Program Bulletin

CUSTOMER SATISFACTION PROGRAM

SUBJECT: Front Strut - Noise

MODELS: 2012-2013 Chevrolet Colorado
2013 Chevrolet Trailblazer

Figure 1

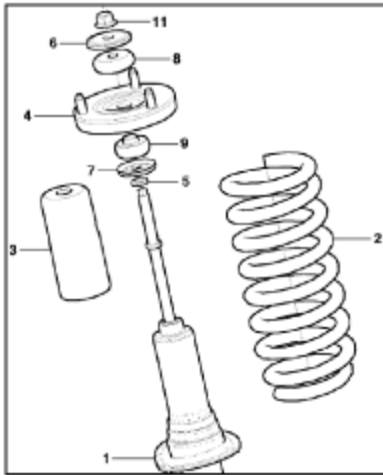
6. Refer to figure 1 - the lower bush (9) will be replaced as well as the spring seat insulator (not shown in figure 1). In addition, inspect the top mount bracket (4), cup washer (7), upper bush (8), and shock absorber rod (1) for damage. Follow these guidelines to determine if these parts should be replaced:

Figure 5 — Check if Silver Washer Has Worn Through

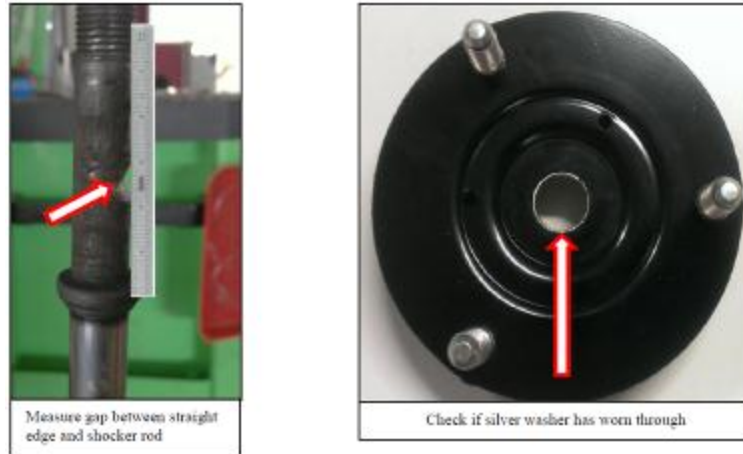
- Inspect the steel washer (silver) that is pressed into the centre of the top mount bracket. If the washer has worn through to the black steel mount bracket, then replace the top mount bracket, refer figure 5.
- Inspect the upper bush (8), if the bush is out of shape or is damaged, replace the bush. In most cases it is expected that the upper bush can be reused. Do not replace it unless necessary.
- Inspect the cup washer (7) for distortion or other damage. Replace only if required.
